22 LANCASTER GROVE

Date: 17th December 2013
Our Ref: 2013/7870/PRE
Your Ref: 9032423
Contact: Charles Rose
Direct Line: 020 7974 1971
Email: Charlie.Rose@camden.gov.uk

**PRE-APPLICATION PLANNING ENQUIRY
22 LANCASTER GROVE LONDON NW3 4PB**

APPEAL BY MISS KATHERINE SOMERS AGAINST THE REFUSAL OF A PLANNING APPLICATION FOR THE ERECTION OF A TWO STOREY BUILDING PLUS BASEMENT FOLLOWING THE DEMOLITION OF EXISTING BUILDING TO PROVIDE FOUR DWELLINGHOUSES (4 X 5-BED)

EXISTING FRONT AND REAR ELEVATIONS

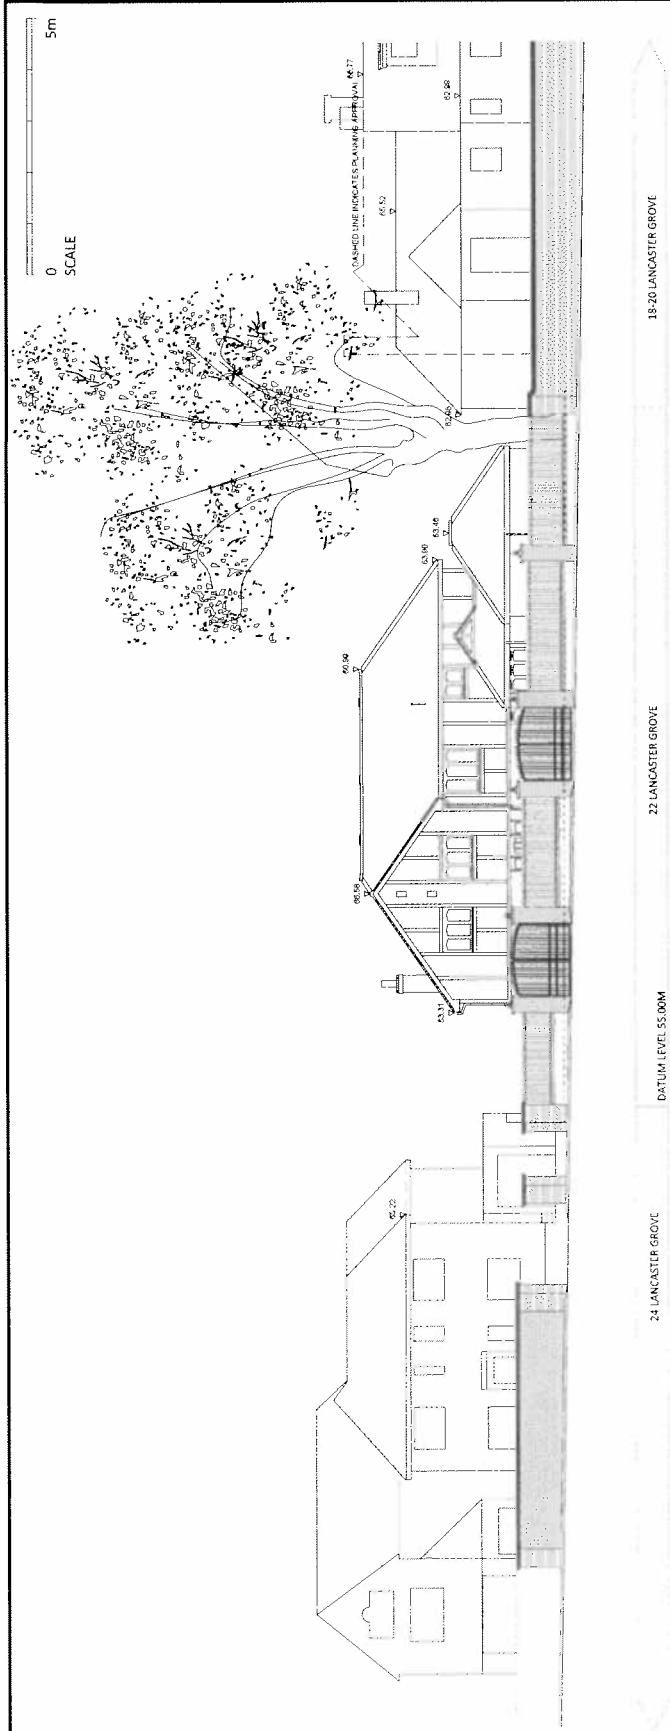
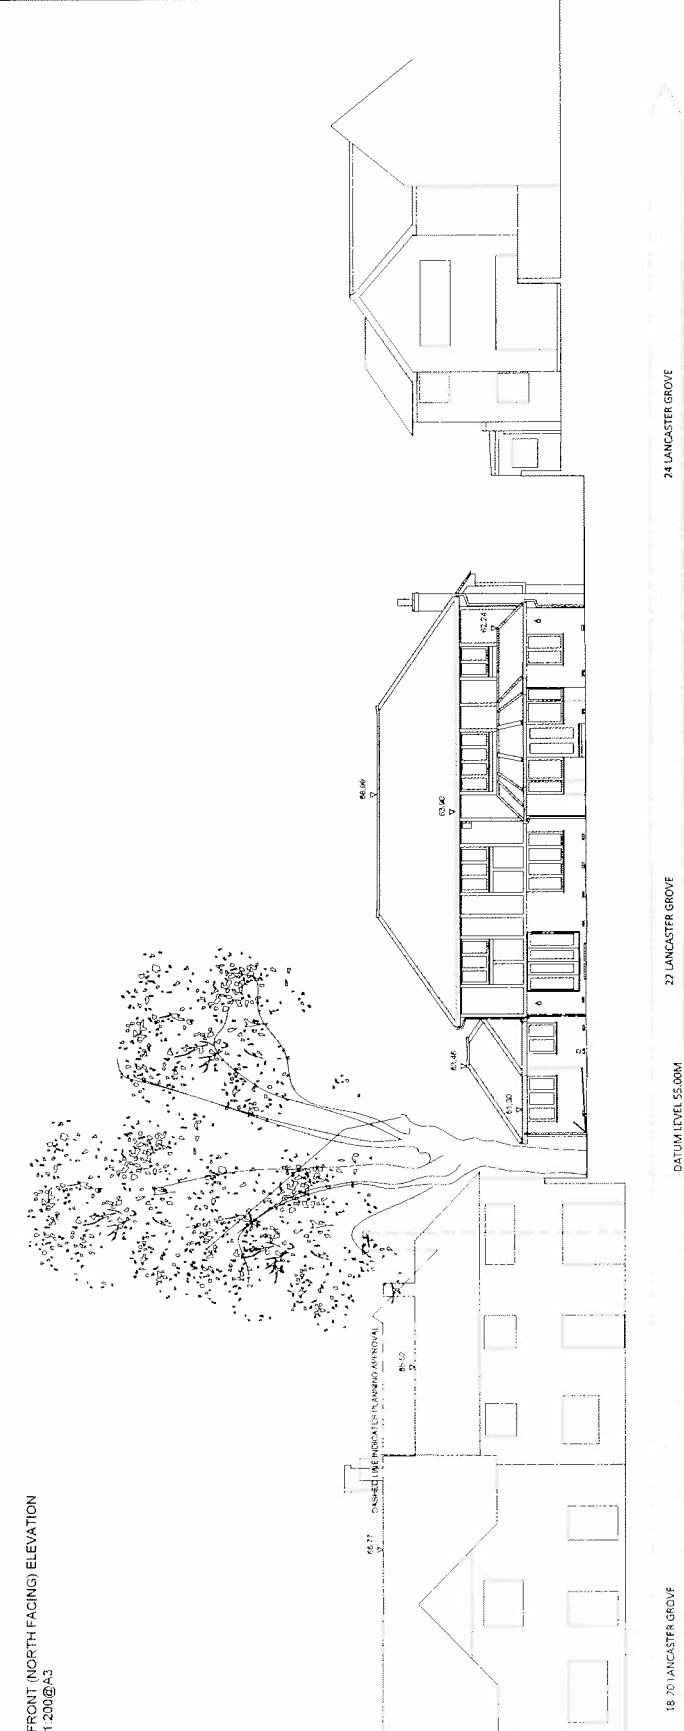
- Elevations of no.24 checked to make sure they are drawn parallel to the front and rear elevation of no.22.
- Ground level and wall level to no. 24 checked.

PROPOSED FRONT AND REAR ELEVATIONS

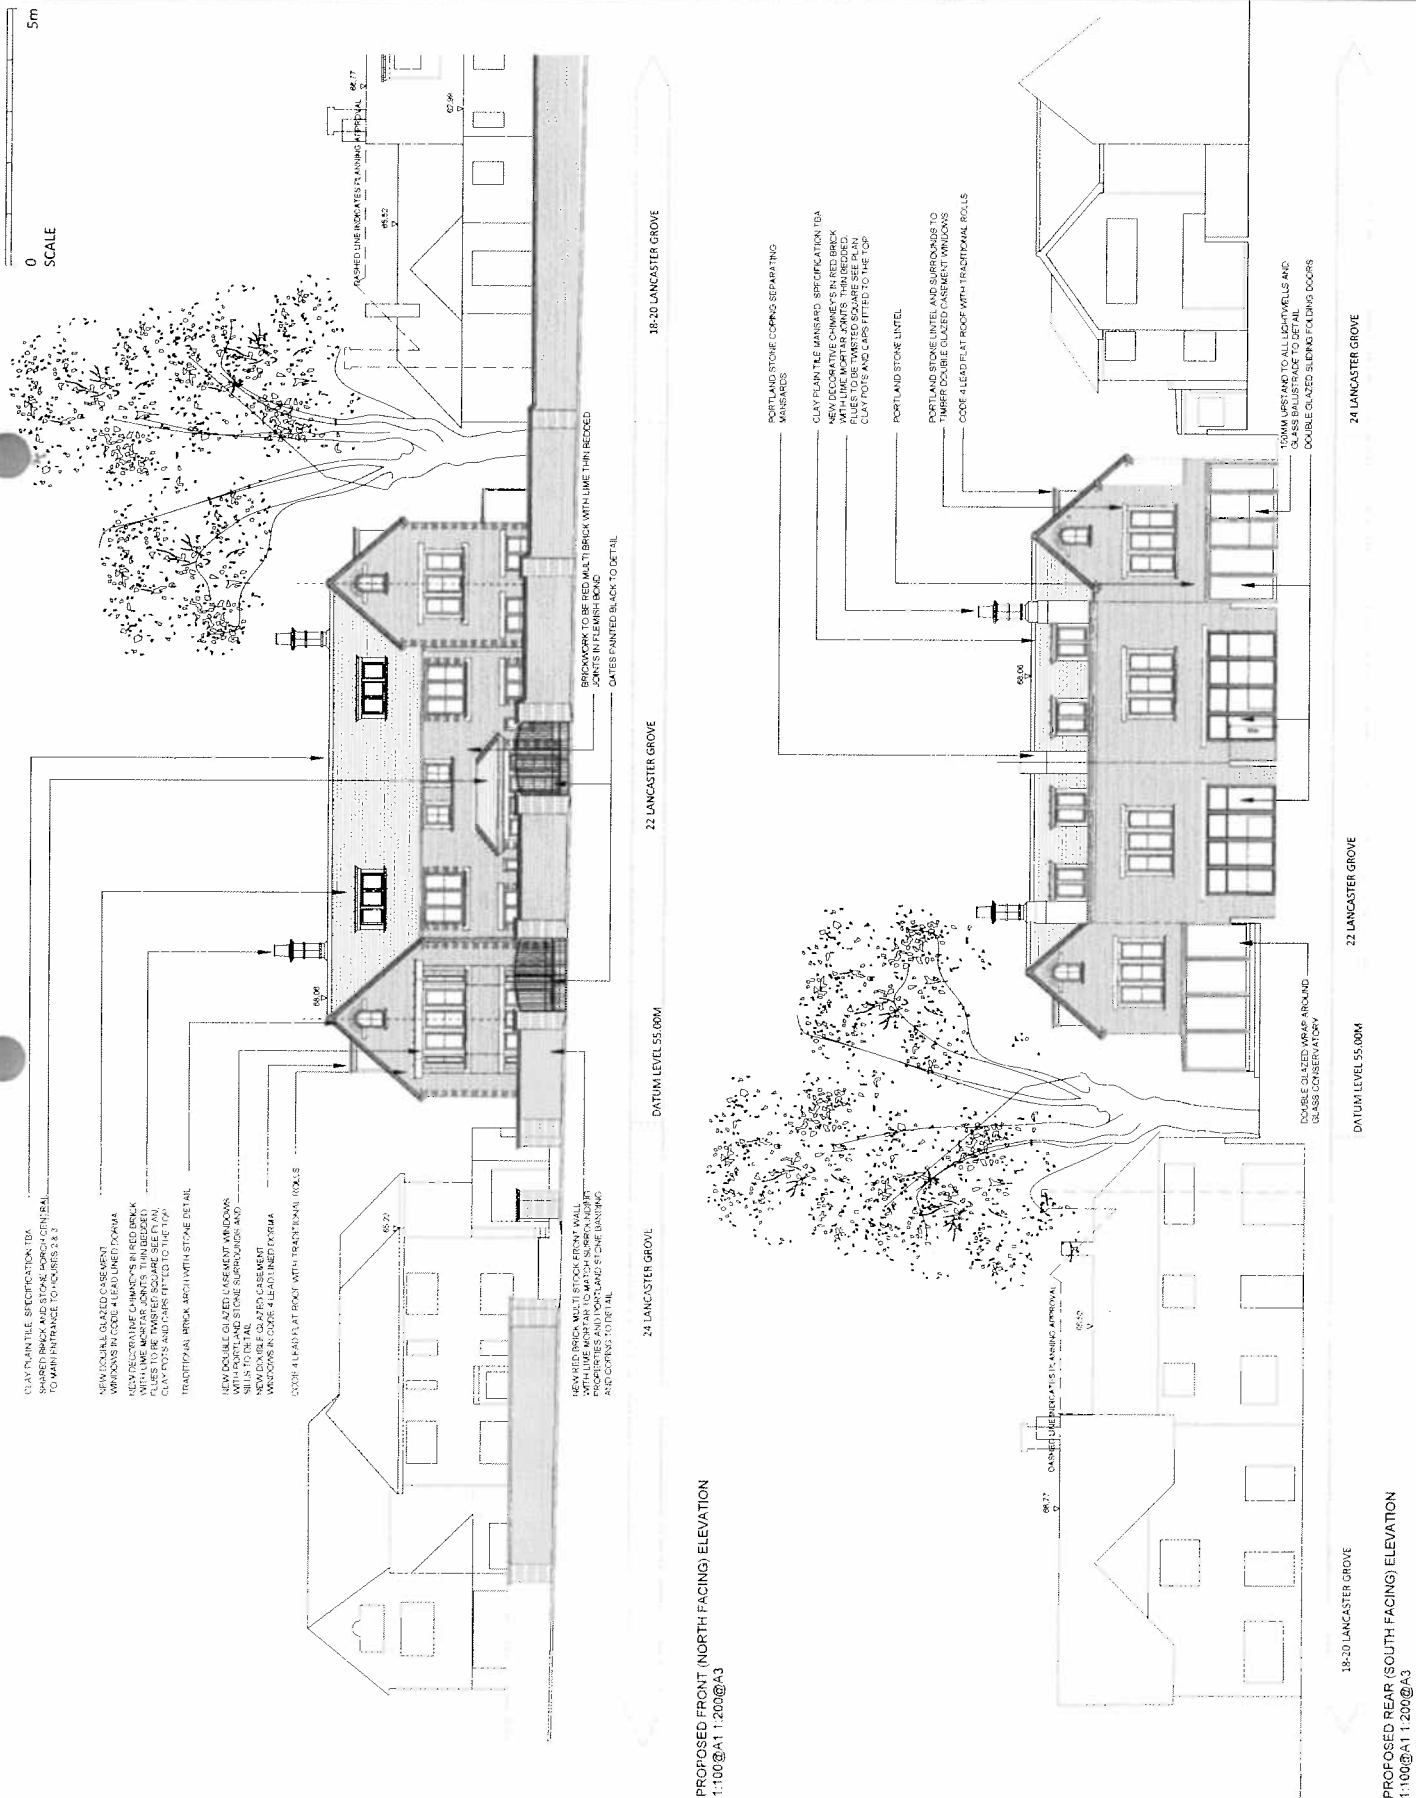
W.D.	CHECK NO. 24 DRAIN COMPLETELY FLAT TO REAR ELEVATION OF NO. 22
N.C.	BOUNDING REDUCED IN HEIGHT REDUCED STONE
N.B.	J4 BOUNDARY ADJUSTED
N.A.	NORTH ADJUSTED

22 Lancaster Grove - Drawings

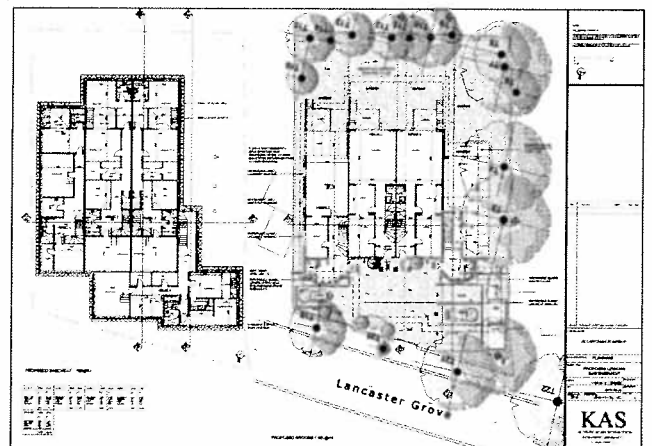
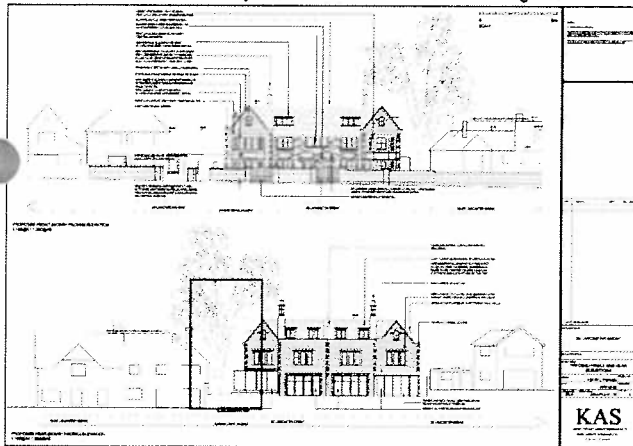
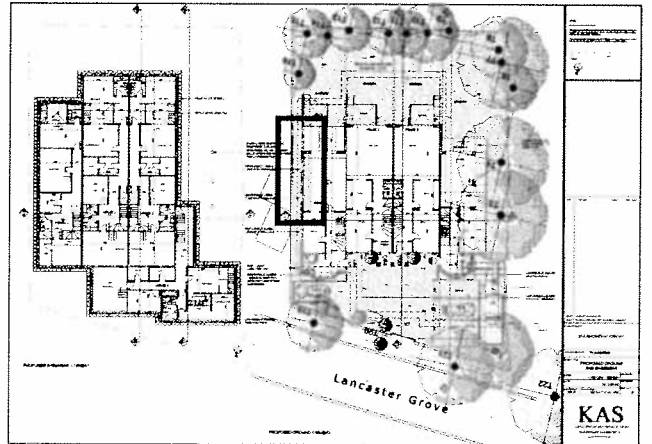
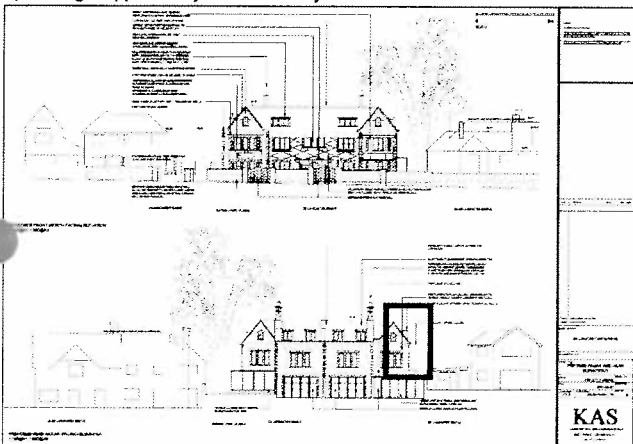
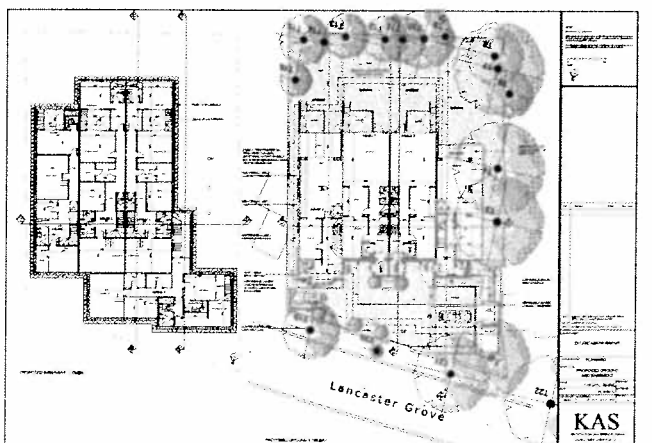
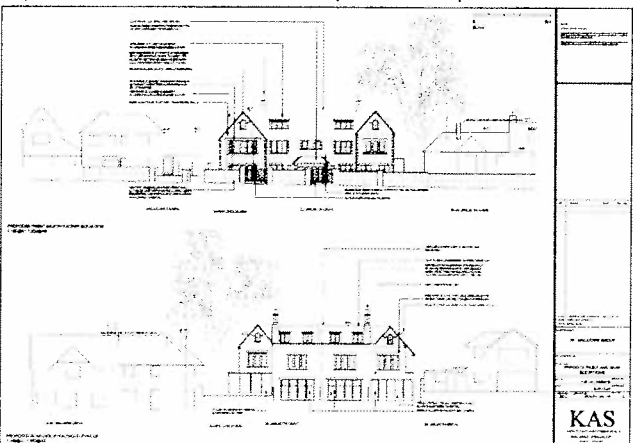
Application Set 21st March 2014 - Rev A - 1) Buildings moved forward, step in build form increased and depth of buildings reduced by 2m, 2) buildings pulled away from the trees on the western boundary in accordance with dimensions agreed with Camden Tree Officer.

Revision Following Consultation with Council 16th April 2014 - Rev B - 1) Building stepped away from no. 24 by 1m above first floor

Revision Following Consultation with Neighbours 21st April 2014 - Rev C - 1) Building height reduced by 500mm to address height concerns. 2) Stone, brickwork reduced. 3) Bay removed from house 4 to address requests for a simpler elevation.

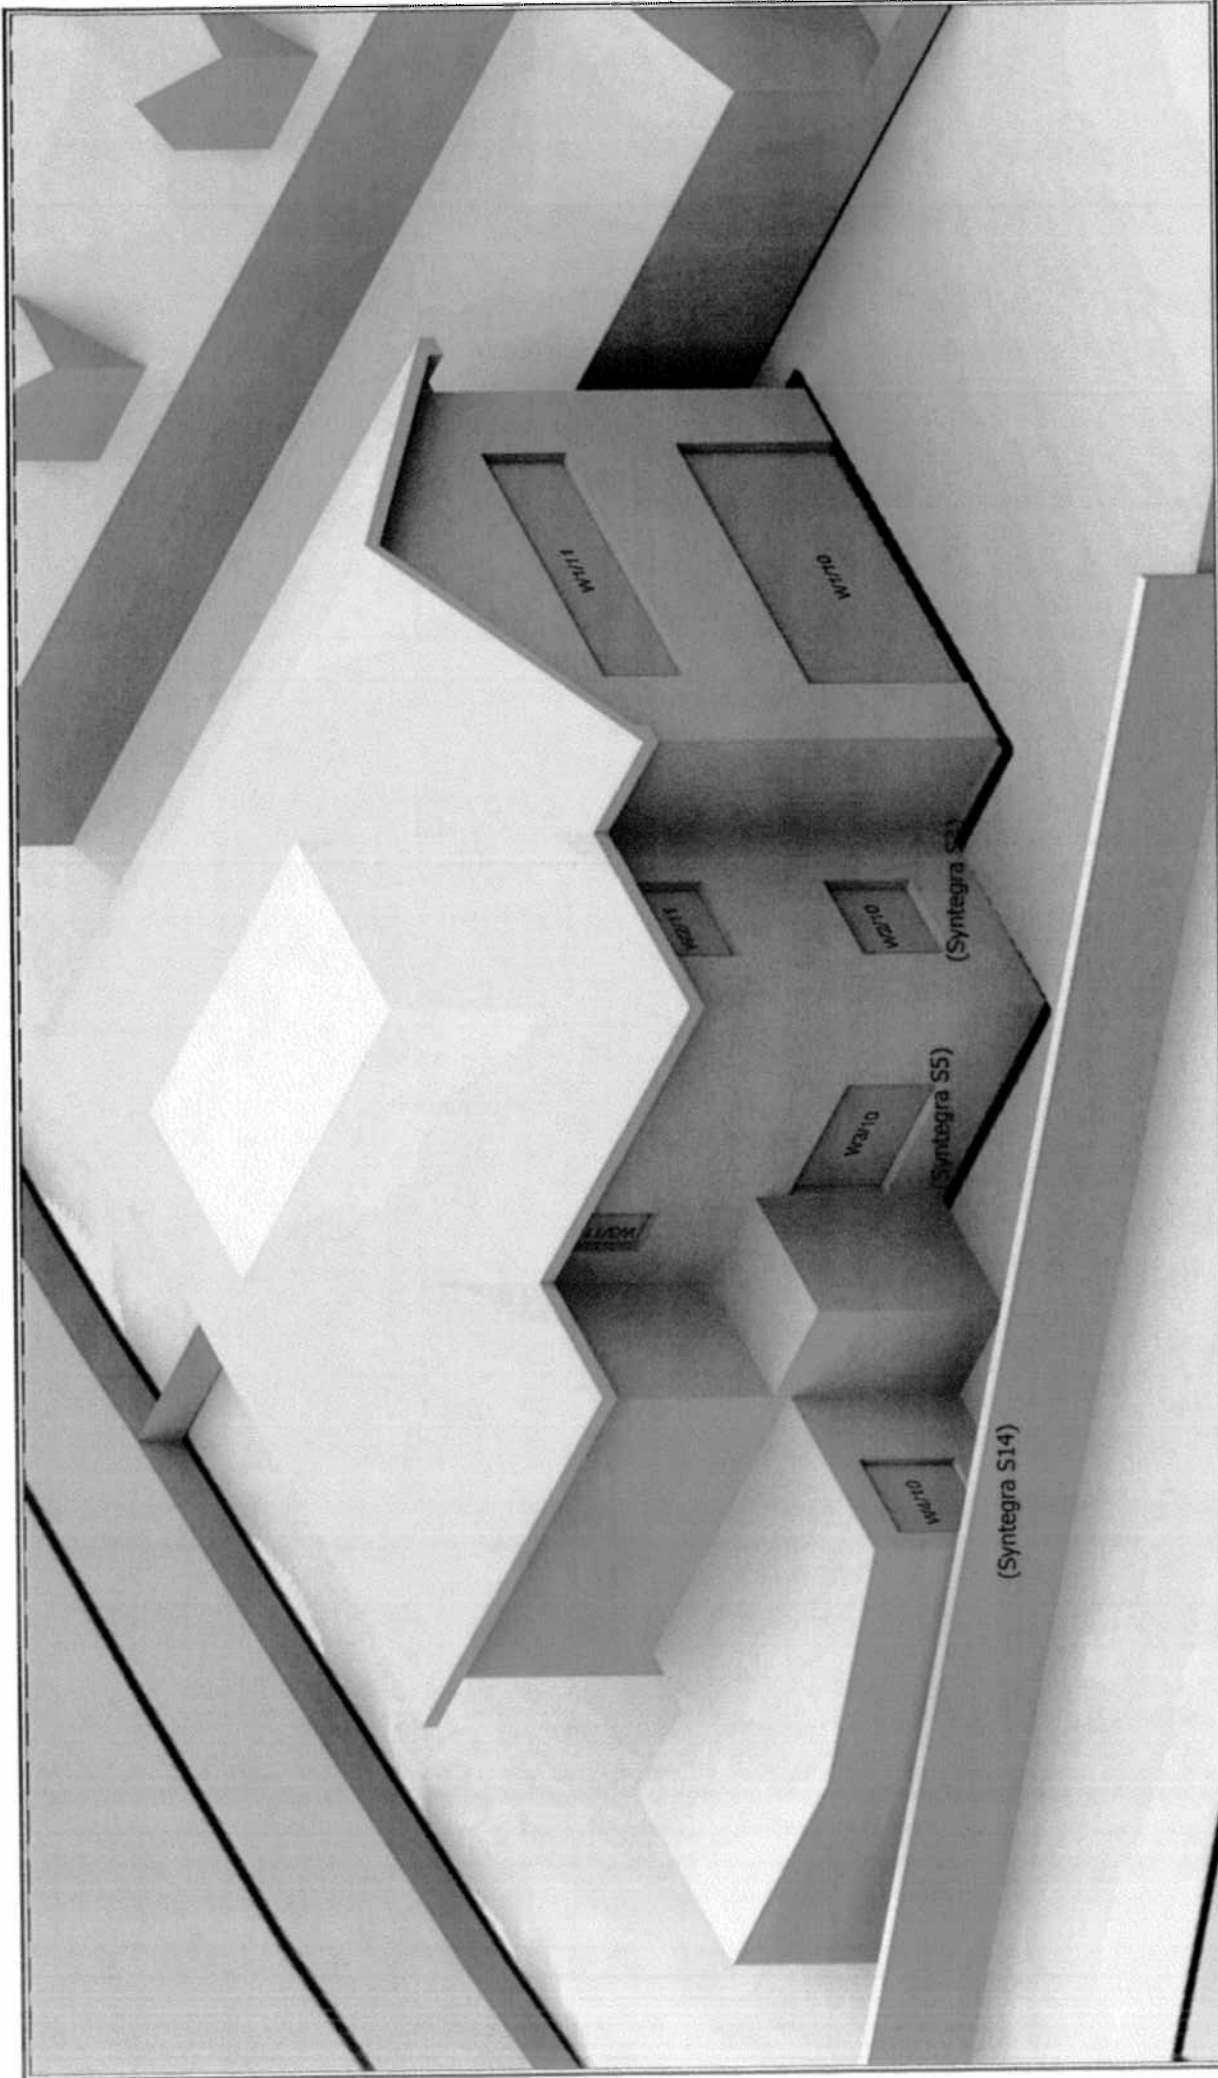
- 4.9 Located to the immediate East of the development site, 24 Lancaster Grove is a 2-storey residential house our understanding of which is illustrated in drawing P382/WL/01 in Appendix B.

- 4.16 Whilst there is a change in the daylight to the Dining room because i) the window (W3/10 in drawing P382/W2/01) looks directly at the development site, ii) is restricted in its current outlook by being flanked by the return of its own building, iii) is at a narrow separation distance from the development site, the fact that it has a second window which looks across the garden means that the retained quality of daylight will be good and is considered satisfactory.

- 4.17 The converted garage has a single window (W4/10) which will breach the window face VSC daylight test. The alteration in the VSC daylight is 37.18% compared to a permitted level of change of 20% which the BRE considers unnoticeable. The window will retain an absolute VSC of 16.54%.

- 4.24 It is worth noting that in relation to the converted garage served by window W4/10 there are a number of viable mitigation measures which would improve the position. For example the addition of a window facing on to Lancaster Grove would provide this space with an additional source of natural light; introducing a glazed panel into the currently solid rear door would admit more light into the room, or the addition of roof lights would also provide a better solution for the room rather than it being entirely dependent upon a single window which faces a tall wall and derives light across the neighbouring property.
